City of Loma Linda Official Report

COUNCIL AGENDA: June 27, 2006

SUBJECT: **APPEAL OF PLANNING COMMISSIONS DECISION TO DENY PRECISE PLAN OF DESIGN (PPD) NO. 05-04** - a request to develop a vacant 5.89 acre site into a business records and self storage business. The project site is in the CM, Commercial Manufacturing zone and located between the San Timoteo Flood Control Channel, the Southern Pacific Rail Road, the Mountain View Bridge, and the community of Bryn Mawr. The project proposes to construct 623 storage units totaling 92,305 square feet and one on-site 1,500 square-foot manager's suite. The applicant has requested that access to the site be provided from the Mountain View Avenue Bridge via Juanita Street. [See Attachment 1(A), Site Location Map]

SUBJECT: **PRECISE PLAN OF DESIGN (PPD) NO. 05-04**

SITE PLAN/PLOT PLAN

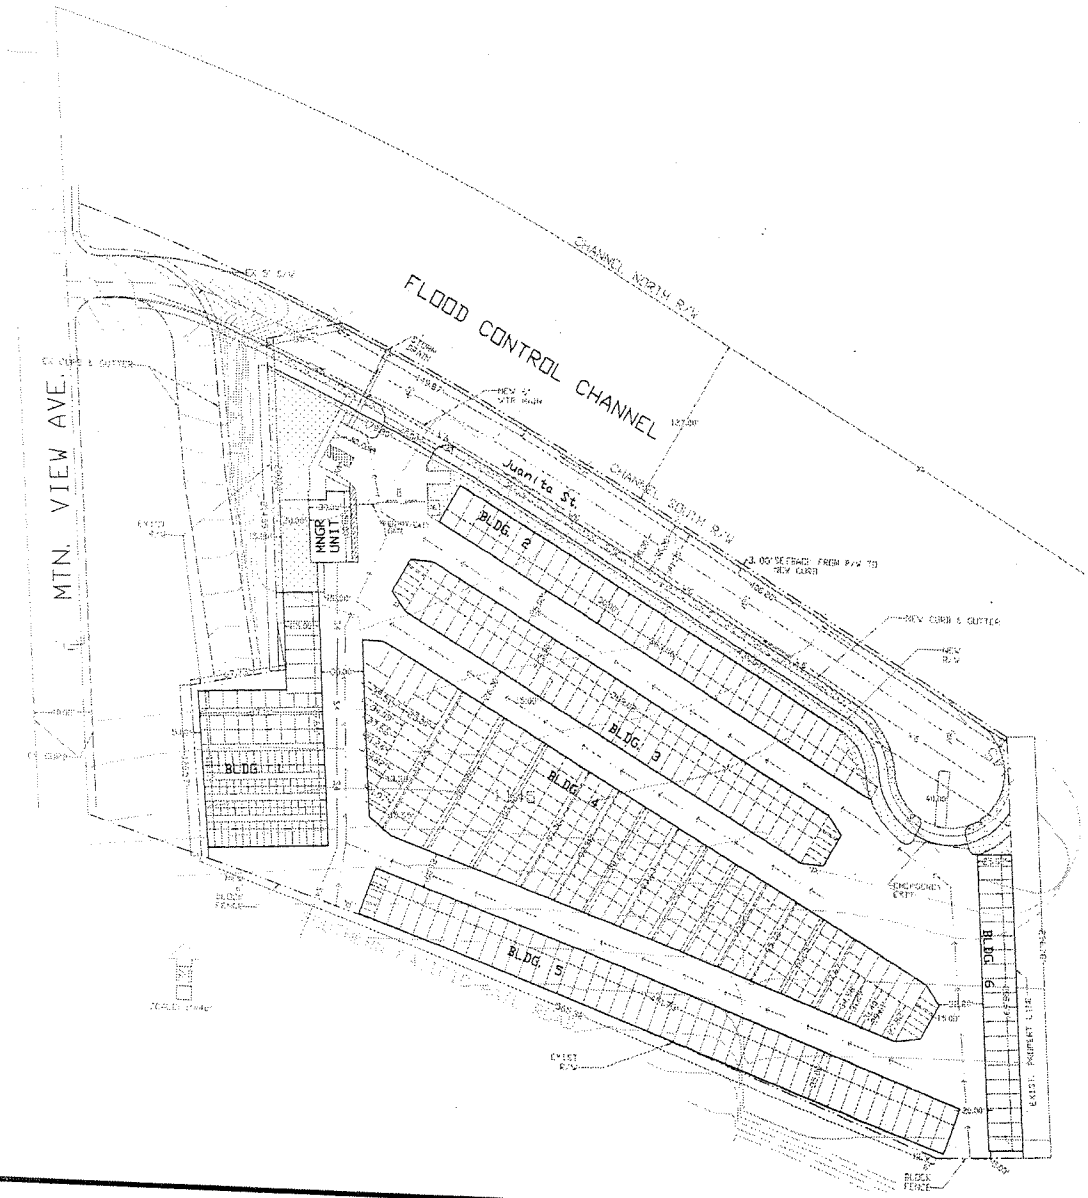
1) Due to sight distance issues, the volume and speed of traffic, and the proposed widening of the Mountain View bridge north-bound lane, access to Mountain View Avenue is prohibited.

2) Please show proposed on-site utilities and drainage (with an illustration of the surrounding site that is at least 15 feet out side of the property line). Easterly and southerly property line appears to block historic drainage patterns.

3) The minimum street width for Juanita Street 60 feet.
4) Please indicate the emergency vehicle turnaround at the end of Juanita Street.
5) Driveways shall be designed with sufficient width and turning radius to allow for the passage of fire apparatus.

8) The proposed wrought iron fences shall be replaced with block walls of slump stone or split face type.
9) Areas between storage buildings at the southeast and southwest corners of the property shall be landscaped.

10) Please provide adequate (approved by the City of Loma Linda Public Works Department) turn around space at the front gate near the proposed parking area.

1. We believe that the City of Loma Linda is obligated to give our client, Universal Self Storage, access to Mountain View and as such exact design to Mountain View has to be coordinated with the City's Public Works Department.

2. On-Site utilities are now shown on the site map.
   a. Sewer Main is north of the Rail Road tracks, which means there would have to be boring under the tracks to access the sewer main with an easement and permit from the Rail Road agency. There is enough slope to get to the sewer main.

b. Water main goes under bridge and could be connected to with our 6" man to serve the property and its fire service.
   c. Drainage is going to be collected through swales on site and taken through site to the Flood Control Channel per std. Dwg 187 a from the San Bernardino Flood Control Standard Drawings.

d. Power line is also under Bridge and could be accessed.
3. We believe there is no need for a parkway and sidewalk on the Channel's side of the street since there are no homes on that side of the street. We provided 36 feet curb face to curb face and half street width on our side of the street of 30 feet. In addition we provided 2.5 feet on North side of the street for grading purposes.

4. We redesigned the end of the street at the Eastern property line to be in an Offset Cul-De-Sac per County of San Bernardino Standard since the City of Loma Linda does not have a specific design for the Offset Cul-De-Sac.

5. We have designed the driveways with sufficient turnaround for Fire Department Trucks and Standards.
6. All construction will meet UBC and UFC stds.
7. We provided location of On-Site Fire Hydrants and our Fire Service Plans would Satisfy the Fire Department comments.

8. The proposed wrought iron fences were replaced with 6' high decorative block walls.
9. Areas between storage buildings at the southeast and southwest corners of the site cannot be landscaped since they are being used to access adjacent storage units. Moreover, the change of the wrought iron fencing with 6' block walls, as requested, screens the before mentioned areas from view from outside of property, specifically the Rail Road Tracks.
10. Front entry redesigned to provide adequate turn around.
11. Windows were added to the second story at the requested elevations.
12. Outdoor access to the restrooms is intended for customers of the facility. The access is beyond the gate making it accessible to customers only.
13. Pedestrian access was intended from the manager's office. However, access was provided and shown.

FLOOR PLAN

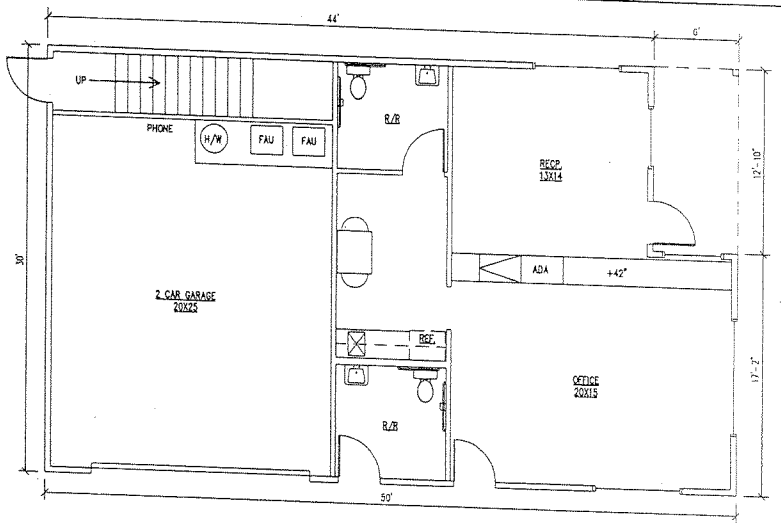
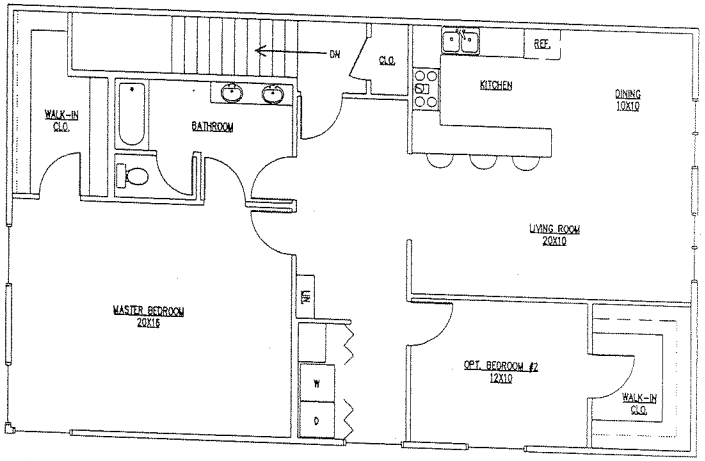
12) Please provide justification for the outdoor access to the downstairs bathroom.
13) Please provide pedestrian entry to the proposed garage for the manager's suite.

ELEVATIONS

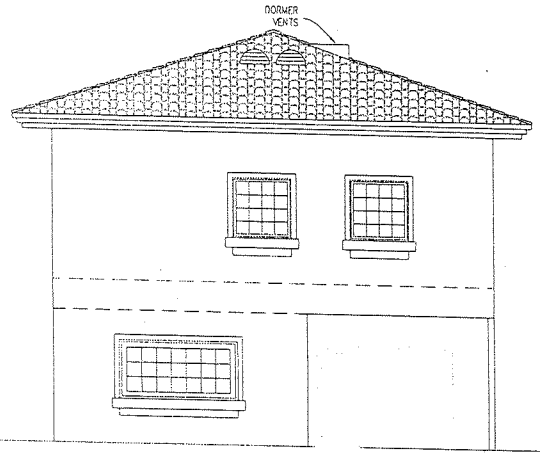
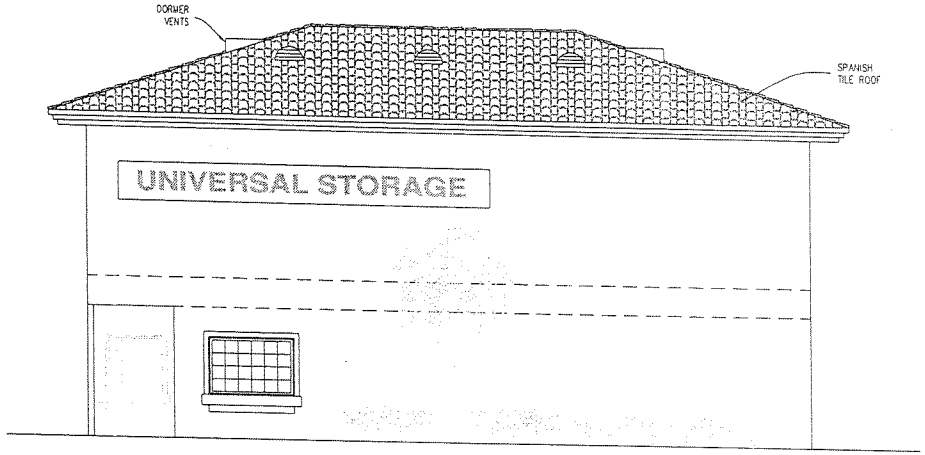
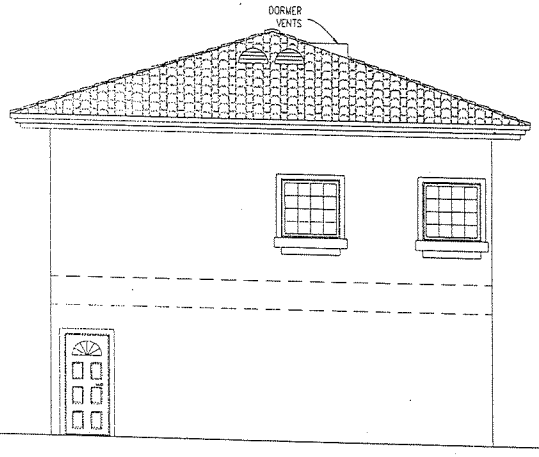
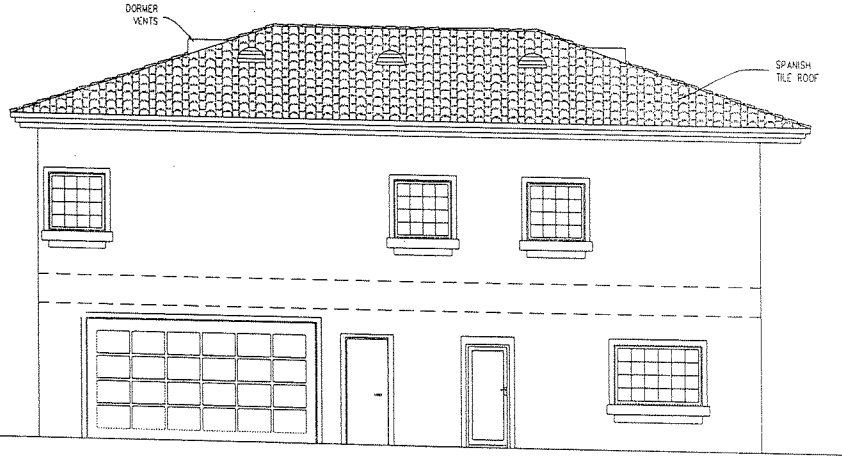
11) Please provide a more distinctive front entry to the office and add windows to the second story of the building on the right, left and front elevations. The office building will also benefit from additional architectural enhancements (i.e. elevations).
